MIL-A-18717B(AS)  
AMENDMENT 1  
27 August 1984

## MILITARY SPECIFICATION

### ARRESTING HOOK INSTALLATIONS, AIRCRAFT

This amendment forms a part of Military Specification MIL-A-18717B(AS), dated 10 September 1979, and is approved for use by the Naval Air Systems Command, Department of the Navy and is available for use by all Departments and Agencies of the Department of Defense.

Figure 1. Typical Arrangement and Details of Arrested Landing Deck Area on CV Type Flight Deck

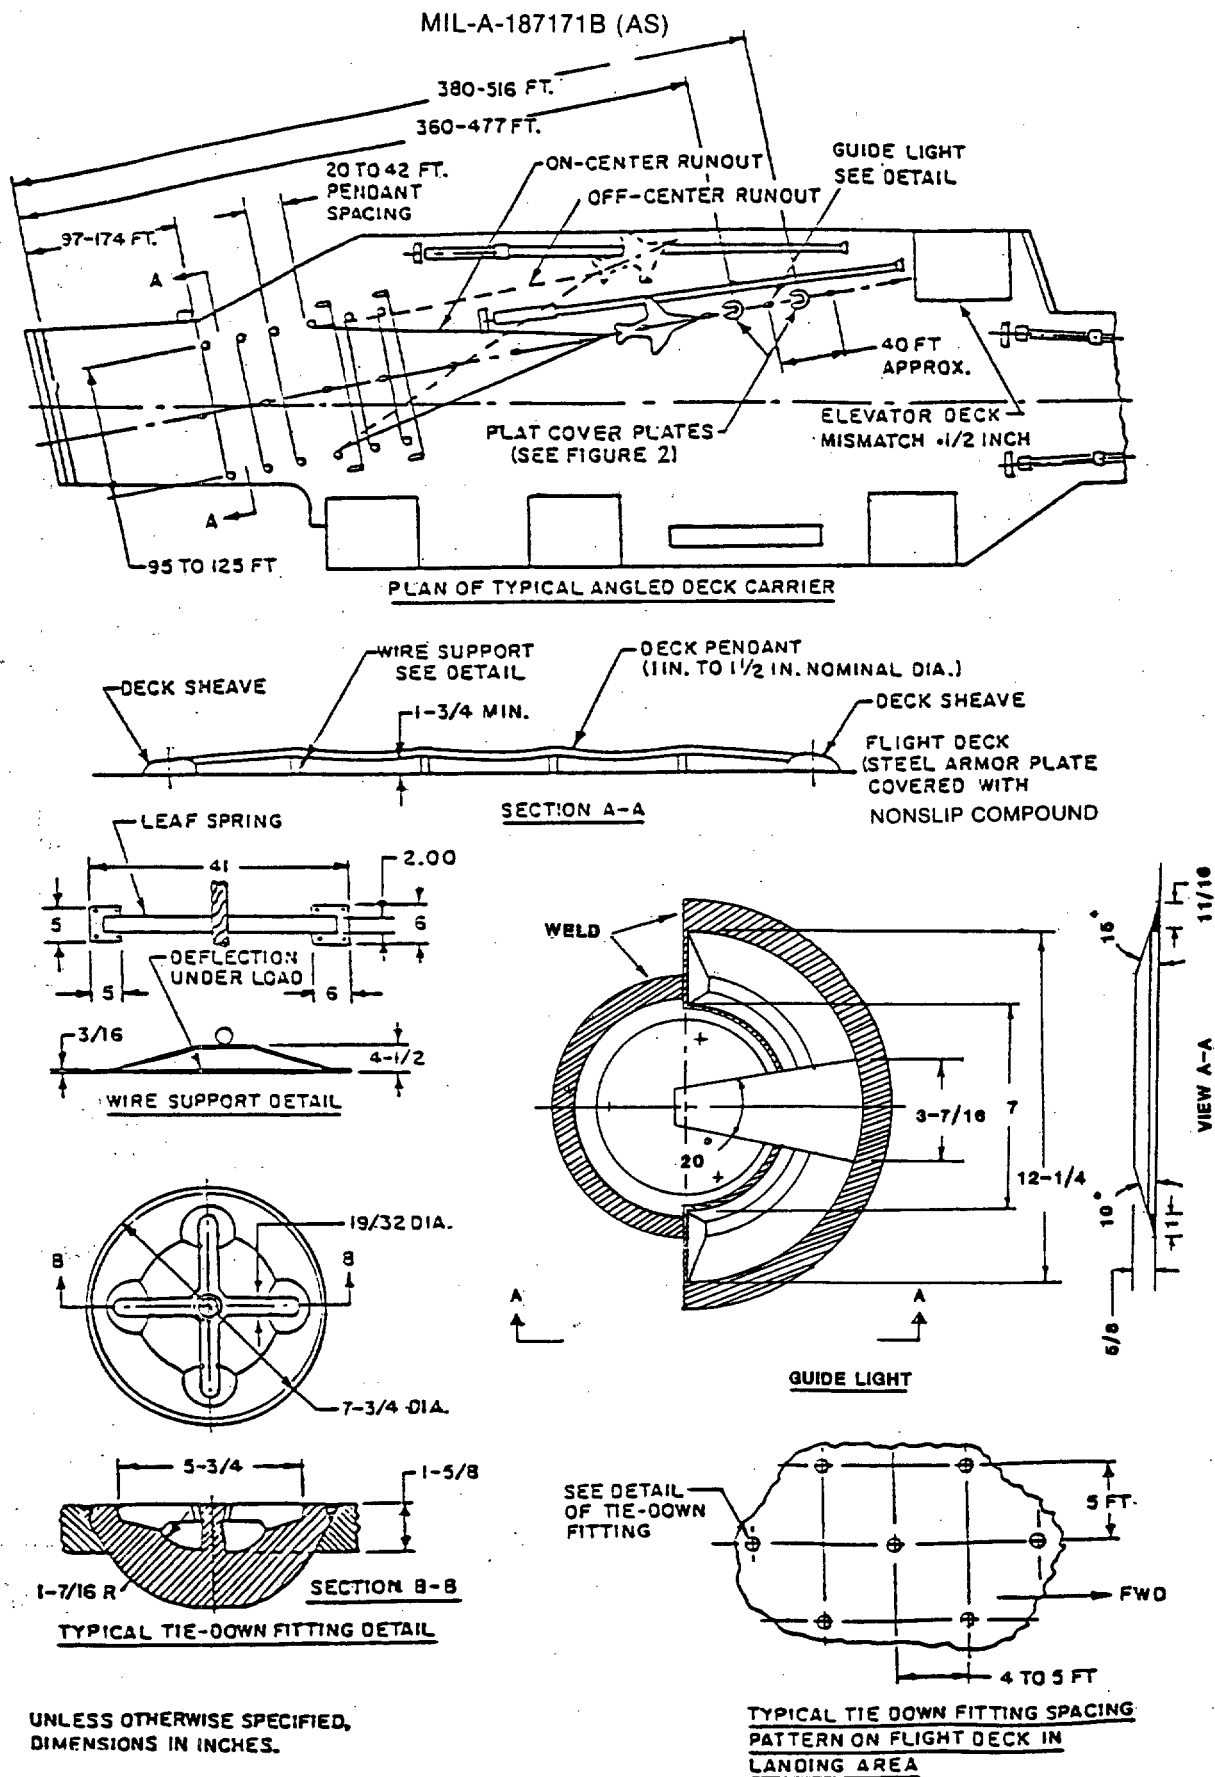
Delete entire Figure 1 and replace with revised Figure 1.

Figure 2. Pilot Landing Aid Television (PLAT) Installation

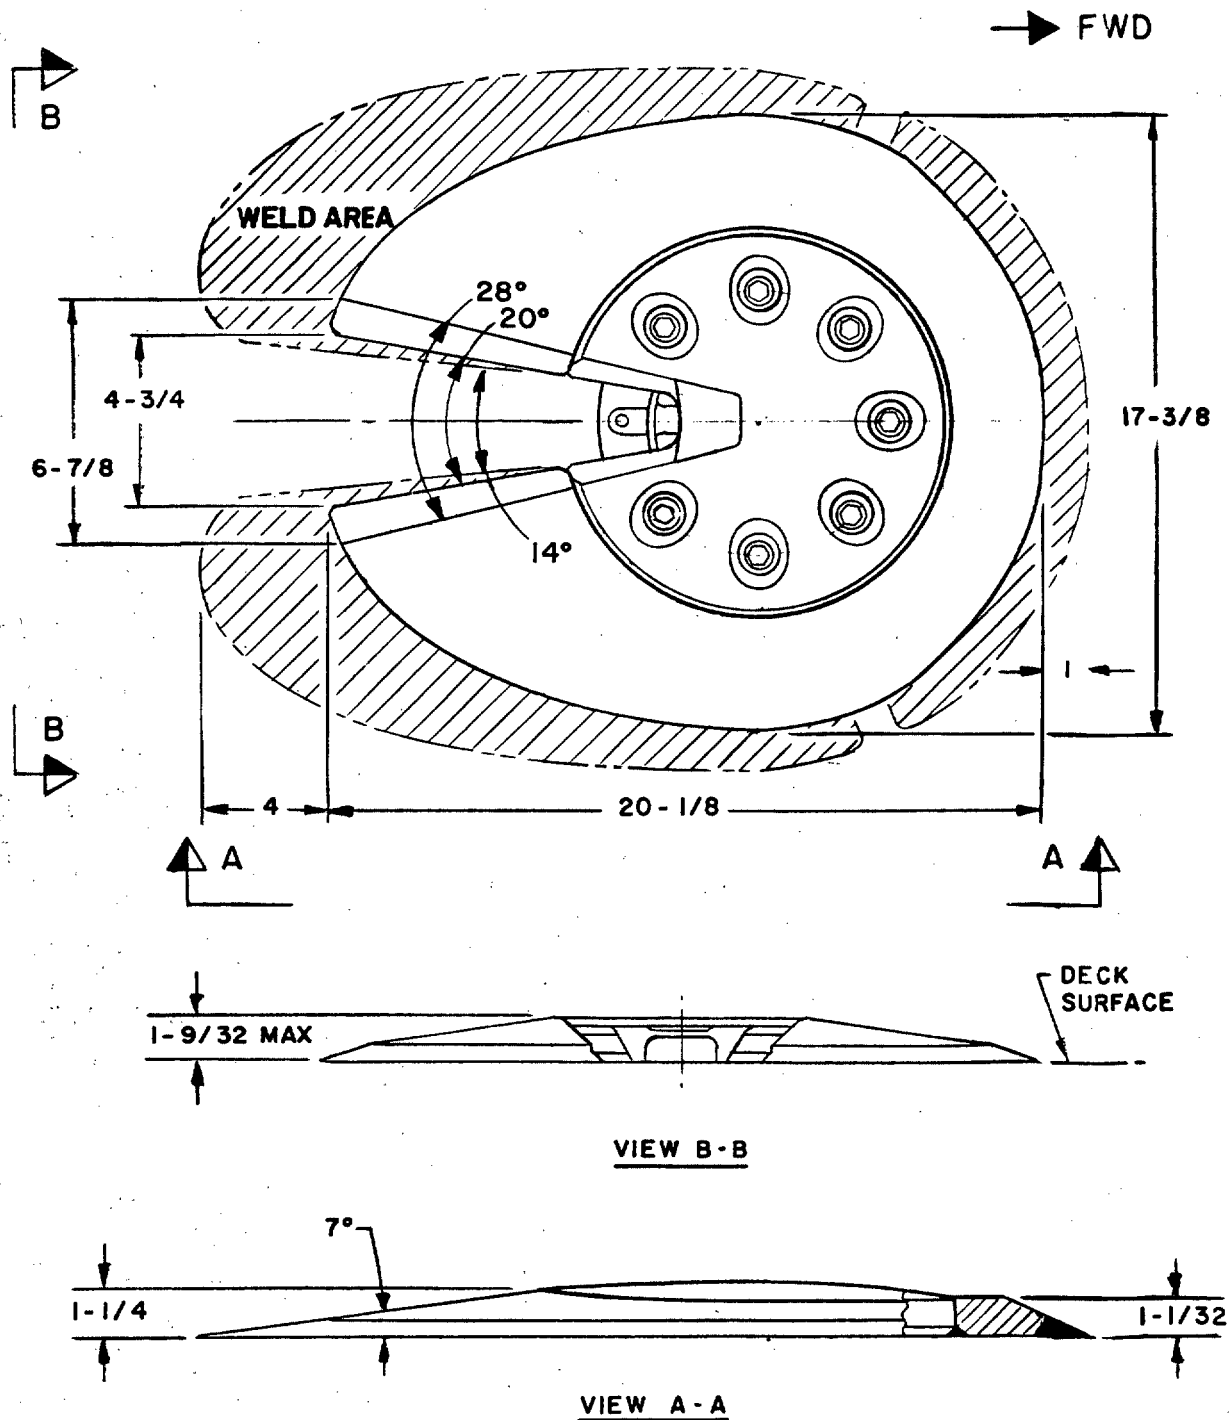
Delete entire Figure 2 and replace with revised Figure 2.

Revise Figure 2 title to read:

"Figure 2 Pilot Landing Aid Television (PLAT) Installation. . . . .5."
